November 4, 1996

APPLICANT: Westinghouse Electric Corporation
PROJECT: AP600
SUBJECT: SUMMARY OF MEETING TO DISCUSS STATUS OF AP600 NOTRUMP LEVEL SWELL
AND BENCHMARK VALIDATION CALCULATIONS

WESTINGHOUSE - NRC MEETING
ON STATUS OF AP600
NOTRUMP LEVEL SWELL AND BENCHMARKING
VALIDATION CALCULATIONS

Figure 5.4-1 Vessel Pressure for GE Test 8-21-1 with 3/8-in. Break

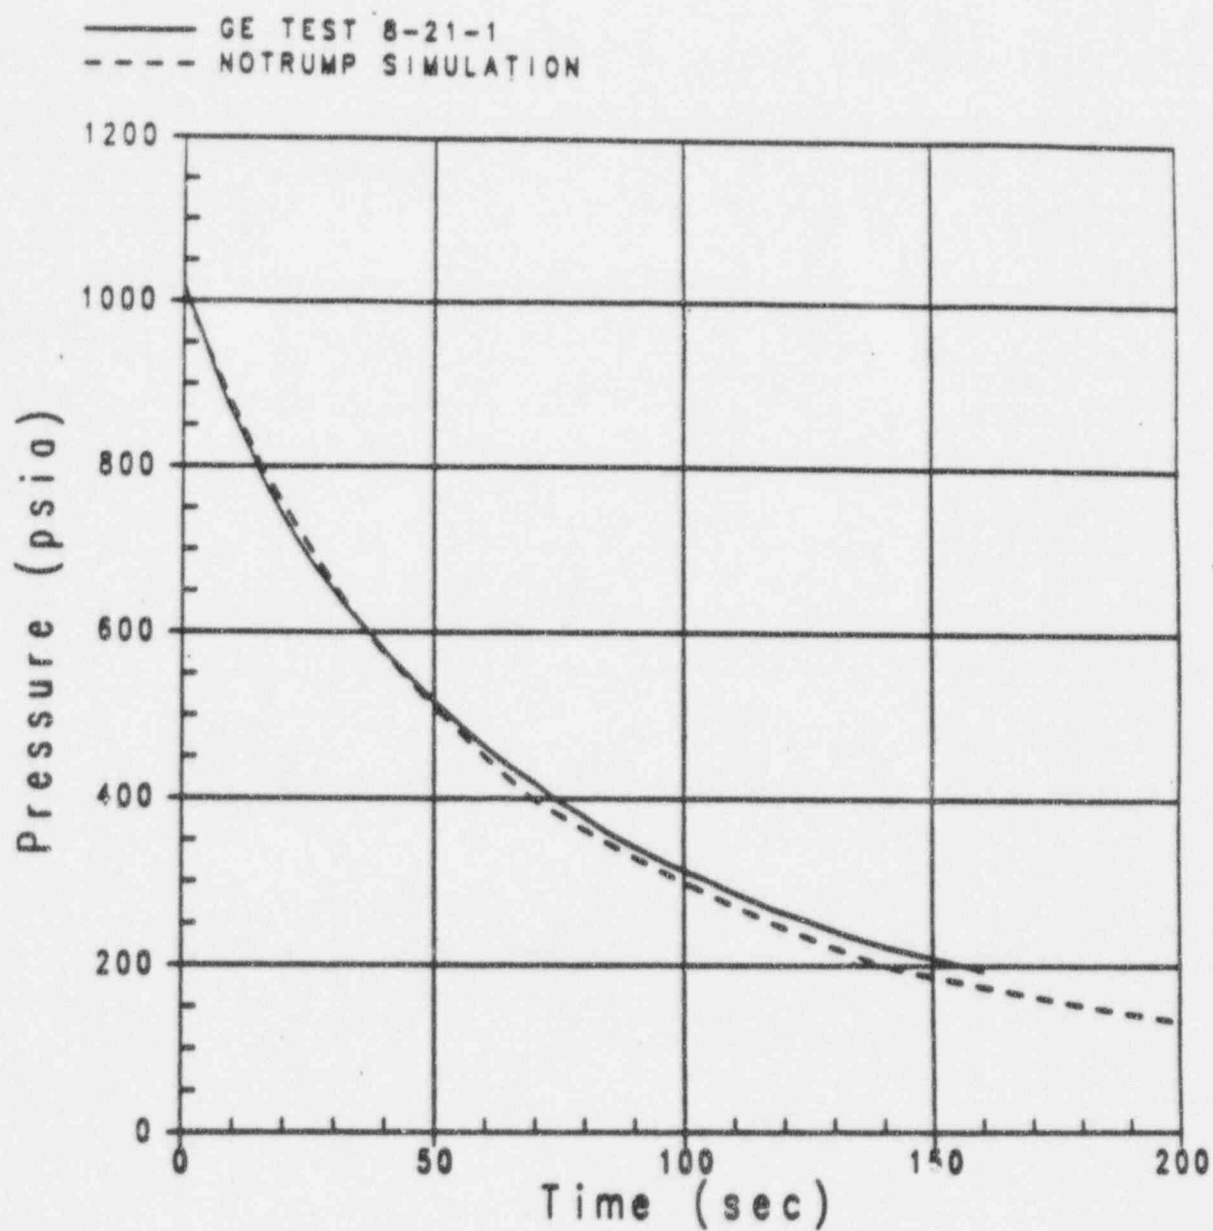
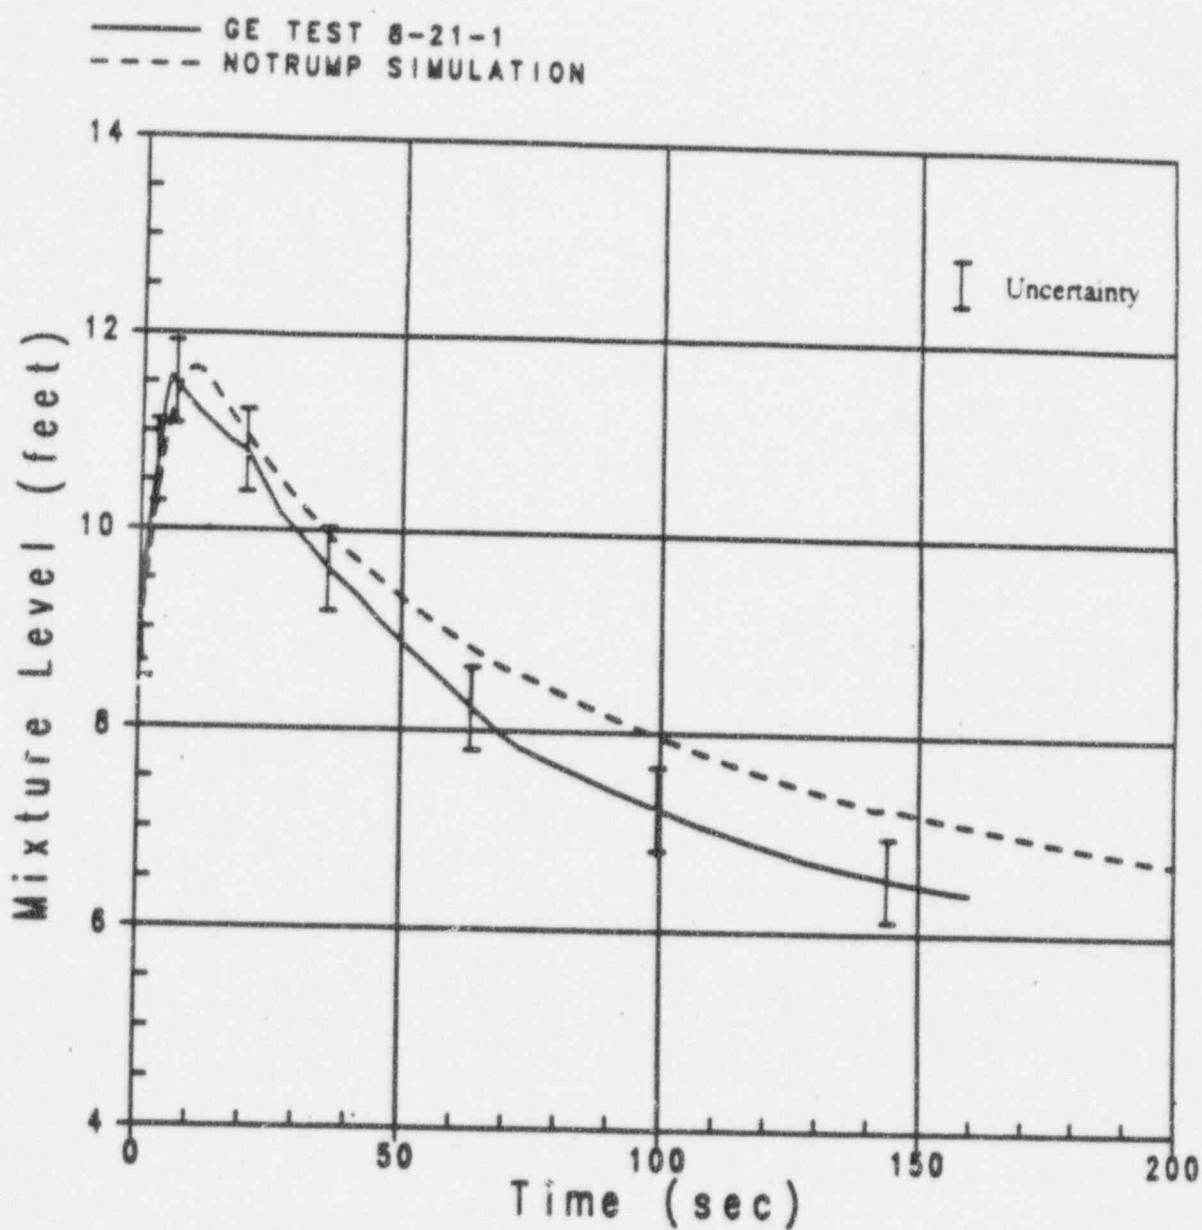
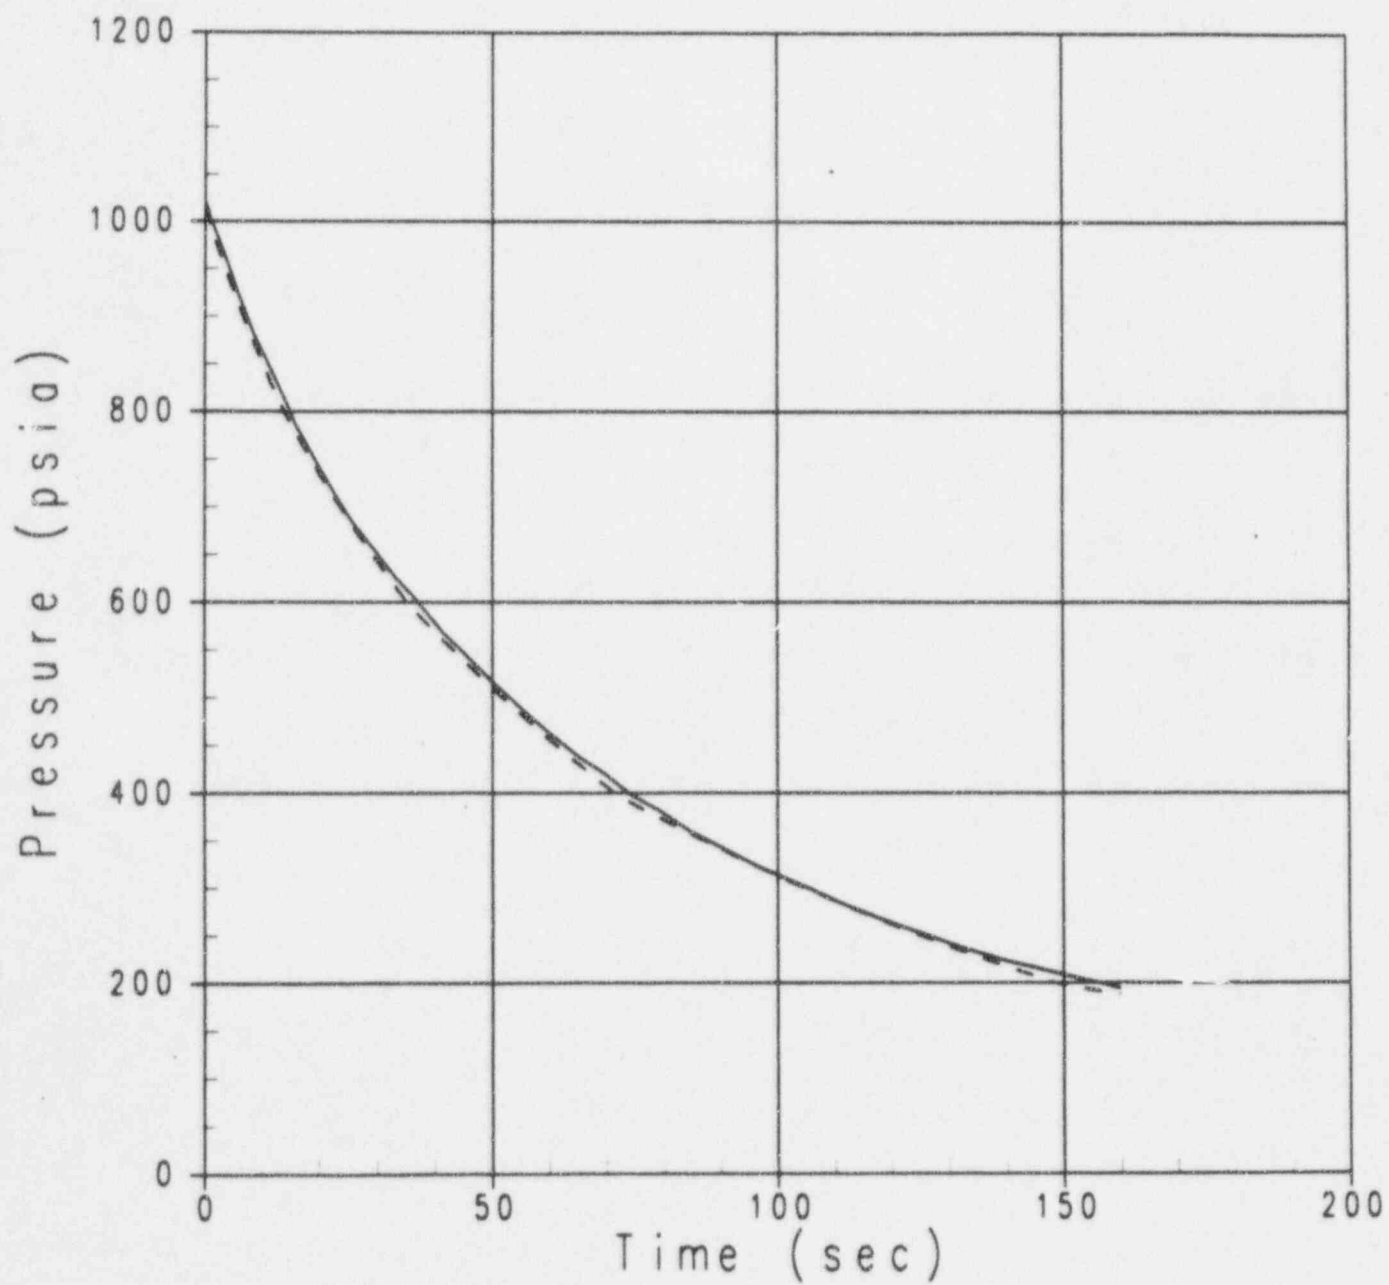
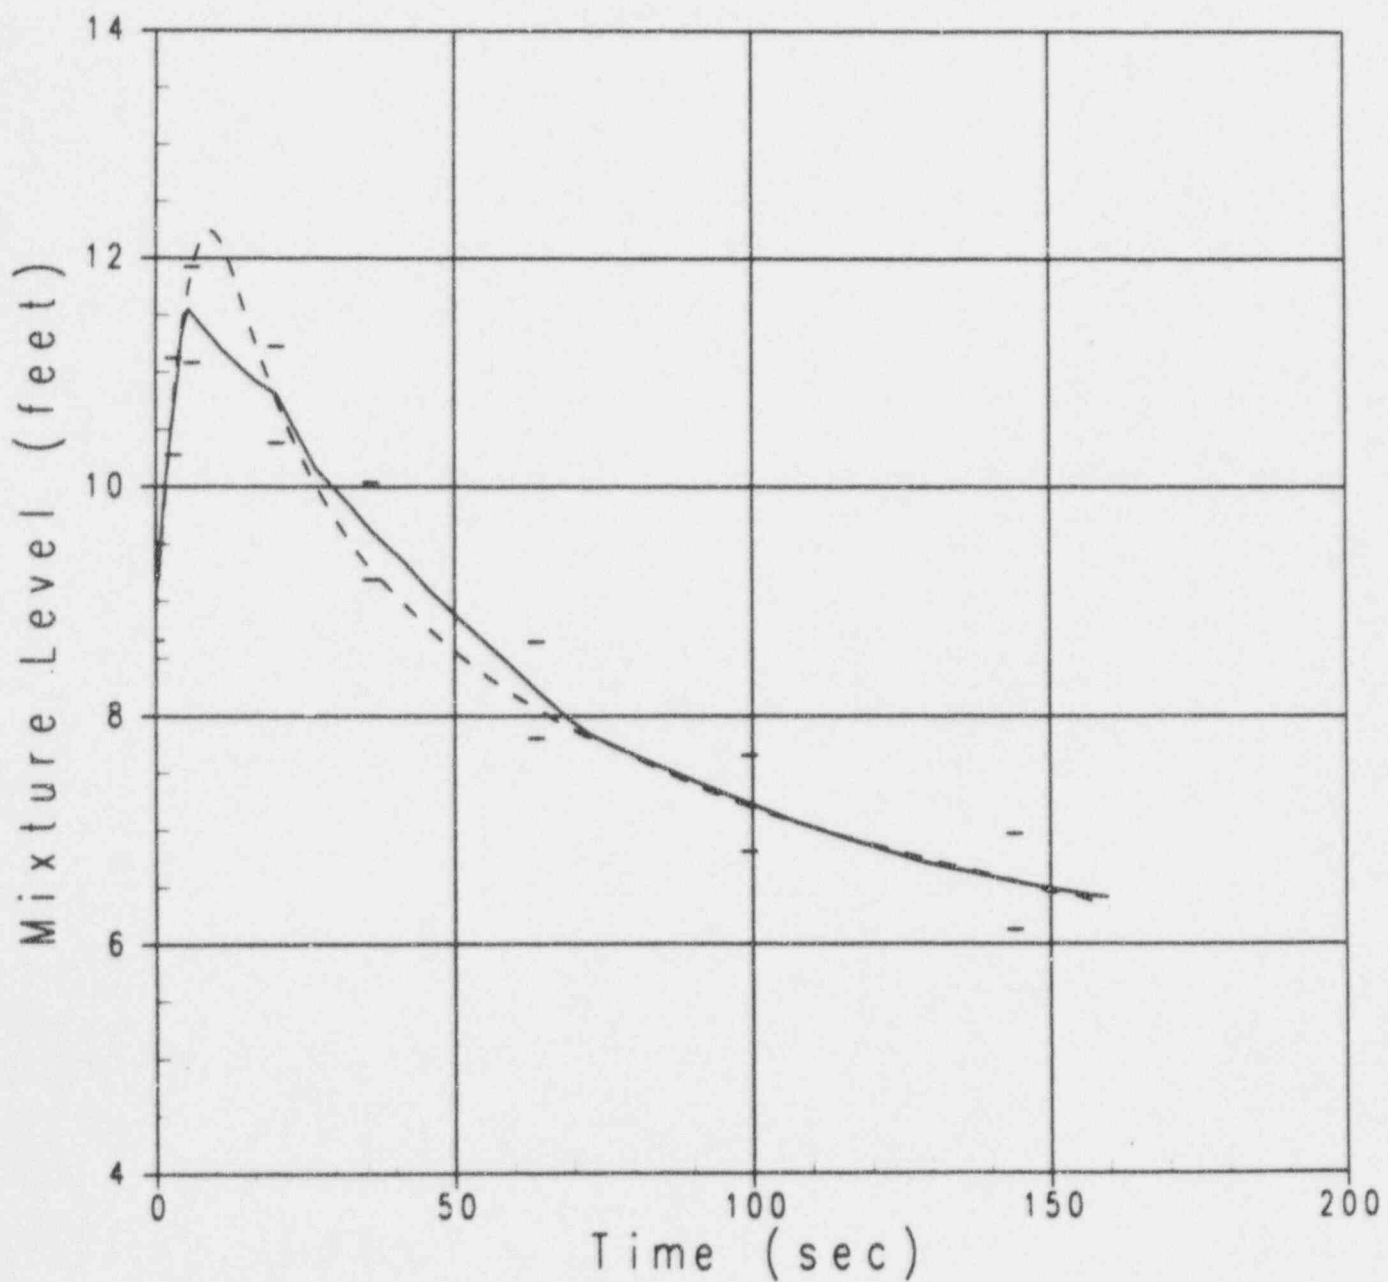
- Westinghouse committed to provide explanation in the final V&V report as to why any previously agreed to benchmarks had been dropped.
- The GE level swell simulation was rerun with a corrected value for the vessel diameter with no impact on the results.

- All simulations complete (GE, ACHILLES, G2)
- New GE simulations performed with revised vessel diameter.
- Conclusions did not change for new GE simulations.
- In process of developing writeups for ACHILLES tests and summary section tying all together.
- Expect submittal to NRC by mid October.
